Memorandum

To: SCL File No: 423022-m-e-c004.docx
Attention: WBOPDC
From: Stephen Bos
Date: 31 May 2023
Subject: Tinex Group Ltd – 245 Te Puna Station Road –
Existing Site Usage - Stormwater Queries

Stormwater Management Response

Figure 1: Times for Overland Flow
Paragraph 2.3.2 b) i)

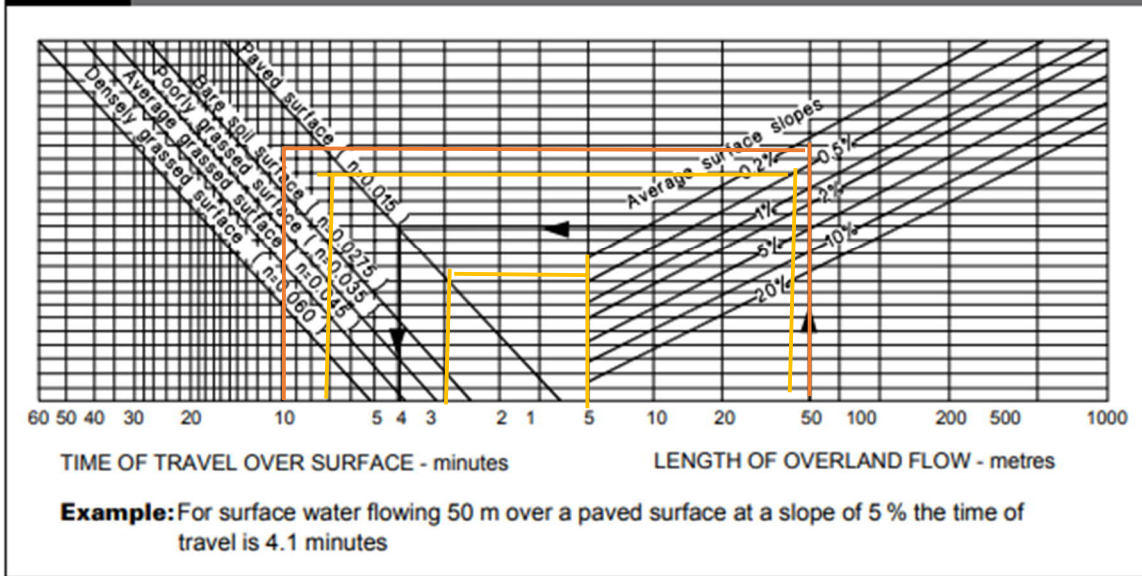
Based on a generalised distance of 50m run from the centre of the site to the nearest drain outlet the minimum time of flow is considered to be around 10 minutes as per the extract from the graph below.

The baseline time of concentration is therefore considered to be in the order of 15 minutes. Based on a reassessment of 5m of paved flow (roof or hard paved object) and then 45m of metallised surface flow the reviewed TOC would be $5 + 3 + 7 = 15$ minutes or equivalent to the baseline.

**Existing Site Plan
 Lot 2 DP 22158
 OVERLAND FLOW DIRECTIONS NOTED**

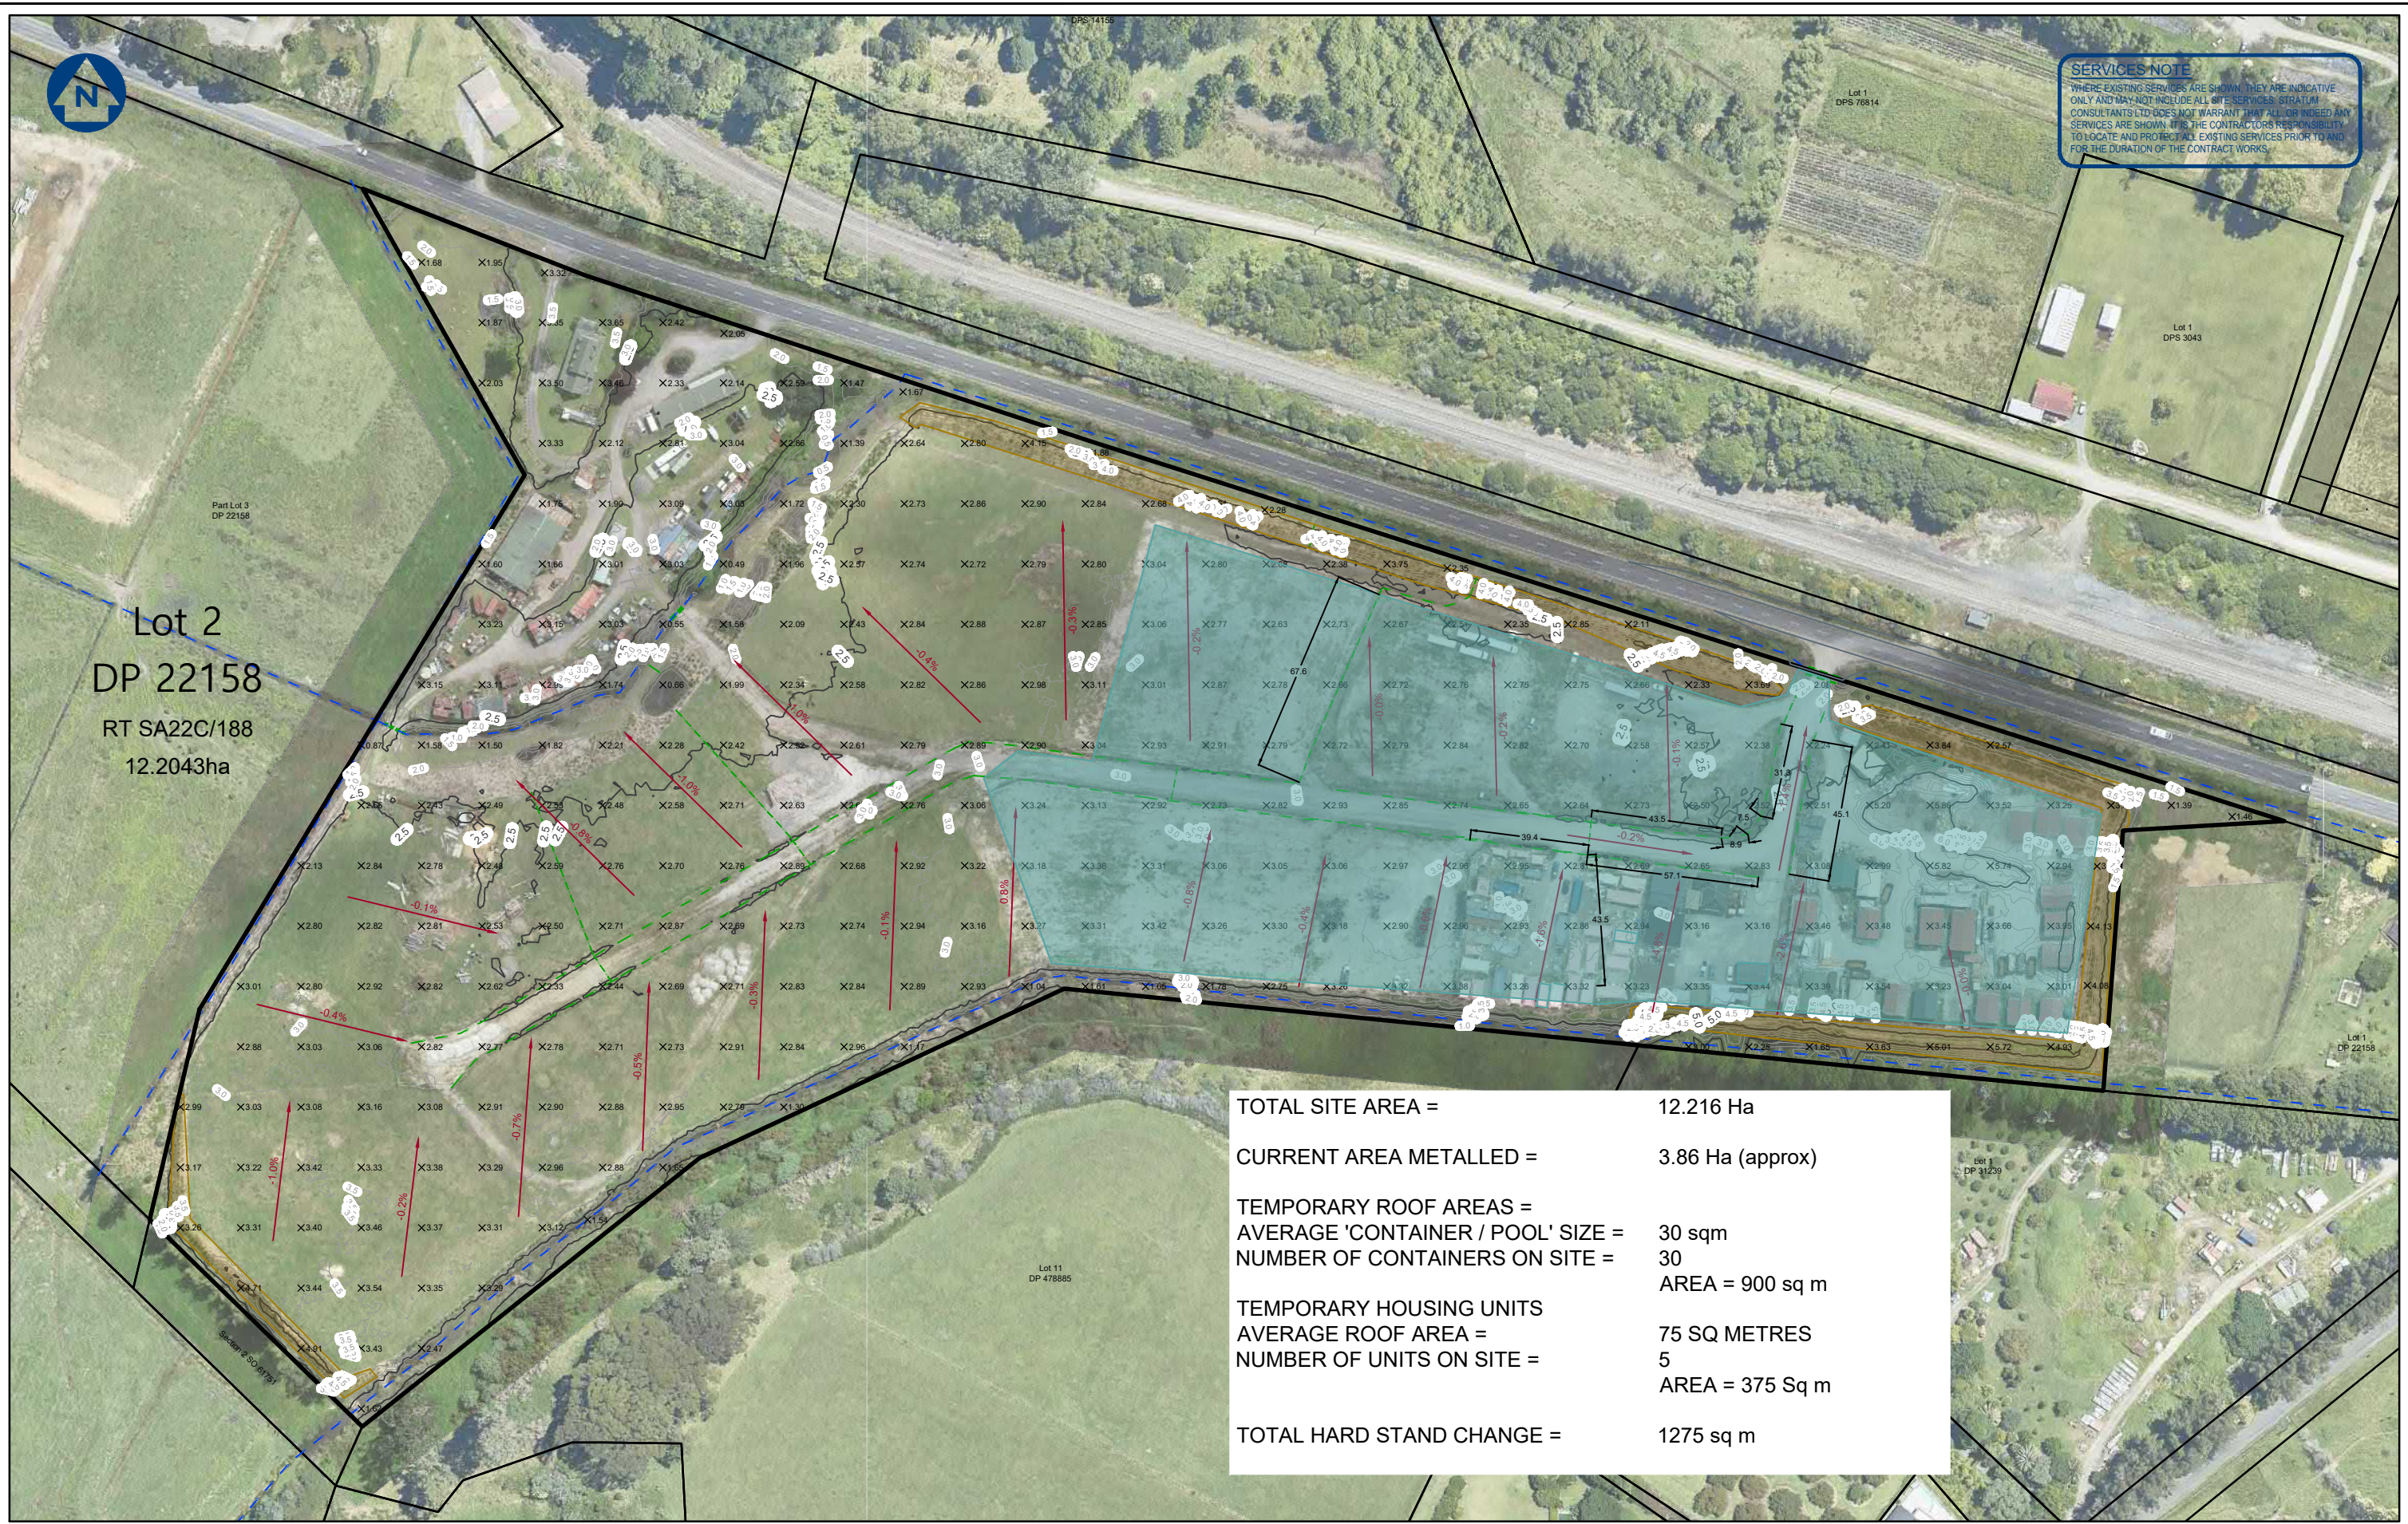
1. The stormwater assessment provided is lacking in technical evidence. Please provide:
 - a) calculations to demonstrate that the stormwater impact from the current users on the overall catchment is minimal.
 - b) Topographic Plans showing the existing land contours/spot heights, and overland flow paths.
 - c) Additional information that further qualifies the statement that *"from the discharge location, the flows disperse across the full site area such that mitigation of the additional flow is considered to occur prior to exiting the individual yard site"*.

Also now included is the identification of the site falls, with noted bunding to the south, east and part north. The existing overland flow paths are shown and there is a series of drains, minor culverts and discharge points that collect the site flow and run this to the existing main drain along the south side of Te Puna Station Road.

As per the attached marked up plan the time of overland flow is considered to vary from the areas closest to the outfall to those furthest away. It is considered that the existing seal yard and flow path runs have been set up to match actual site activities, however these are also considered to be reflective of the site should no activities be undertaken and the yard be sealed only. It is reasonable to assume that water table drains would be formed across the site to enable the collection and discharge of surface water landing on the site.
